Preferred Project Report and Response to Submissions

St Leonards Commerce Centre Concept Plan

Submitted to
Department of Planning
On Behalf of Winten Property Group

November 2010 **•** 09485

Figure 1 - Building Height Average - Elevation North

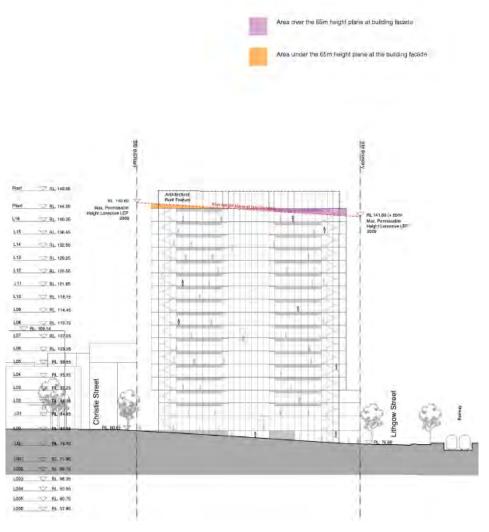
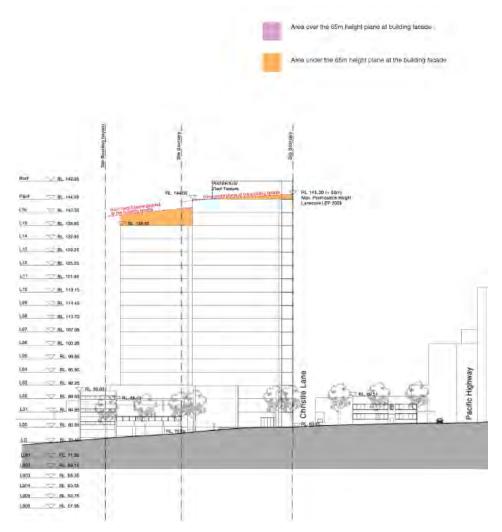
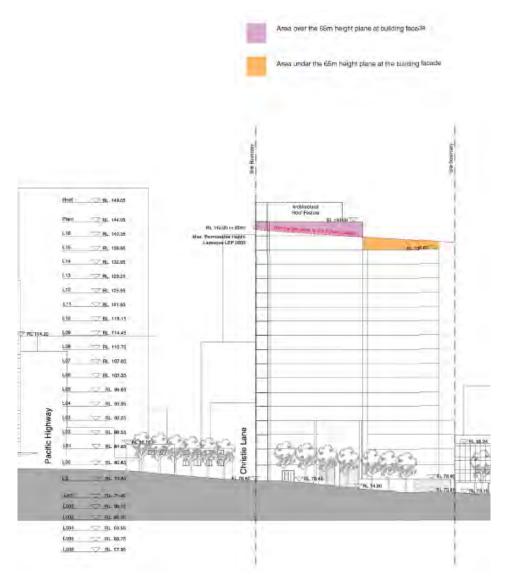
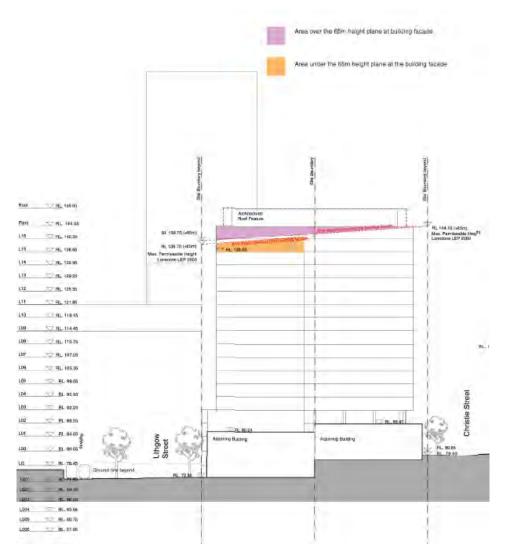
The proposed building exceeds the 65m height limit in the Lane Cove Local Environmental Plan. The impact of the height is exacerbated by the monolithic building envelope, particularly on the northern elevation to the Pacific Highway.

In direct response to concerns raised with the height of the building, the maximum building envelope height has been reduced by 0.7m to RL 149.05. The southern portion of the proposed envelope, which abuts the adjoining commercial development to the south, has also been reduced by 1.2m to RL 136.65.

Whilst it is difficult to definitively quantify the areas over and under the height limit due to the sloping topography in two directions relative to the floorplates, an indicative set of figures has been produced to provide an average or proportionate representation. This shows that compliance with the maximum 65 would result in the loss of one commercial floor, and would challenge the viability of a second commercial floor. Refer to Figures 1 – 4. These Figures are also included in the architectural set at Attachment D.

Figure 5 - Northern facade articulation studies

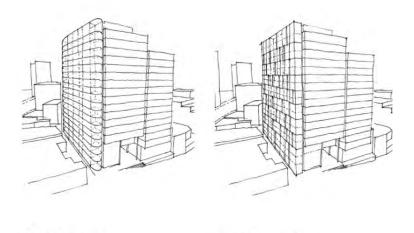
The concern has been raised that the northern facade of the exhibited Concept Plan envelope represents a "monolithic" envelope or form. To address this matter, Bates Smart has remodeled the potential envelope, floorplates, and facade articulation to produce more refined northern facade that addresses the concerns raised.

- the northern facade's width has been reduced by 12m from 63.58m to 51.58m;
- the flat envelope along this facade has been articulated in plan form either side of the lift core, such that the elevation of the envelope now reads as three distinct planes; and
- further articulation is provided at the corners of the envelope at the northern facade.

The indicative choice and pattern of transparent and translucent materials and potential colours along with the uses / active functions (visible lifts, stair wells) at this part of the building will assist in further breaking up what was considered a long and monolithic facade.

Figure 7 - Architectural roof feature studies

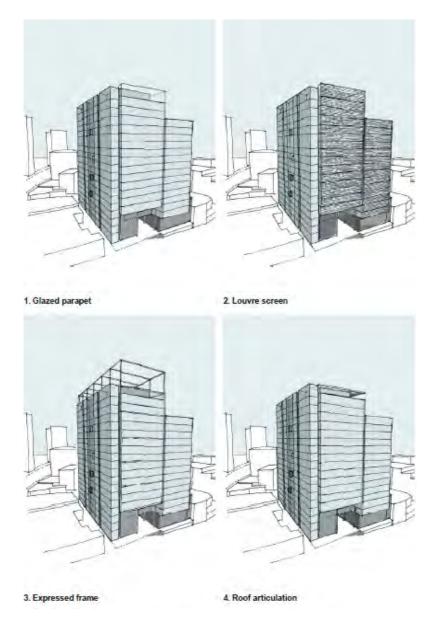
In Council's submission it raised issue with the plant level shown in the architectural drawings in the Exhibited Concept Plan not being an Architectural Roof Feature (ARF). The exhibited drawings, which showed the plant room as a plain block envelope on top of the building, do not reflect what the final design of the ARF.

The envelope shown on the plans represents the maximum amount of space required to house the necessary mechanical plant for the future building. The final design of the ARF will satisfy the relevant criteria in clause 5.6 of the LEP. Whilst the design is yet to be resolved, Bates Smart have prepared a series of studies to illustrate how the ARF could be designed. These are shown at **Attachment D** and **Figure 7**.

Figure 8 - PPR envelope view loss to The Forum Apartments

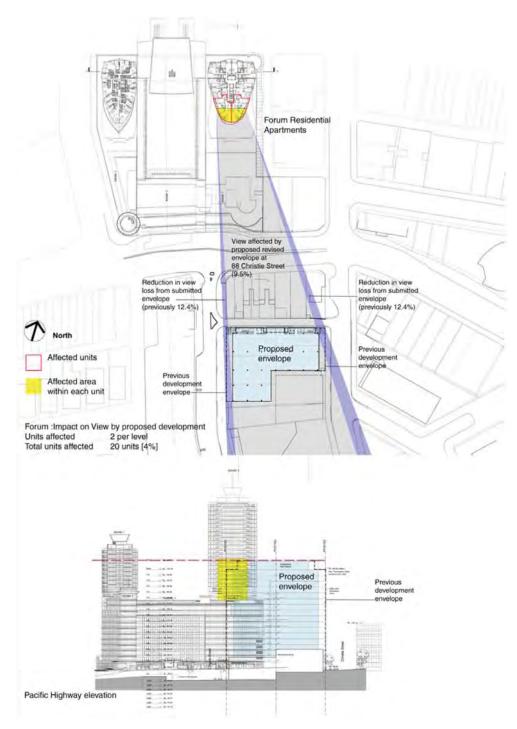
The proposed building will affect views from residential and commercial properties on the northern side of the Pacific Highway, particularly The Forum and The Forum West residential towers.

The attached analysis (as part of **Attachment D**) identifies that the proposed PPR building envelope will affect 9.5% of the existing view corridor from the southern elevation of the Forum residential apartments from levels 14 to 24. As originally submitted, the proposed building envelope affected 12.4% of the existing view corridor (see **Figure 8** below).

Views below level 14 and above level 24 will not be affected. Only 2 units per floor over 10 floors on average are affected, or a total of 21 out of The Forum's 483 units (i.e 4% of total units) - see **Table 1** below. This is considered to be a relatively minor effect, particularly given the pre-existing LEP height and FSR controls, and the strategic planning objectives that encourage taller premium floor plate commercial buildings to be established within this part of St Leonards.
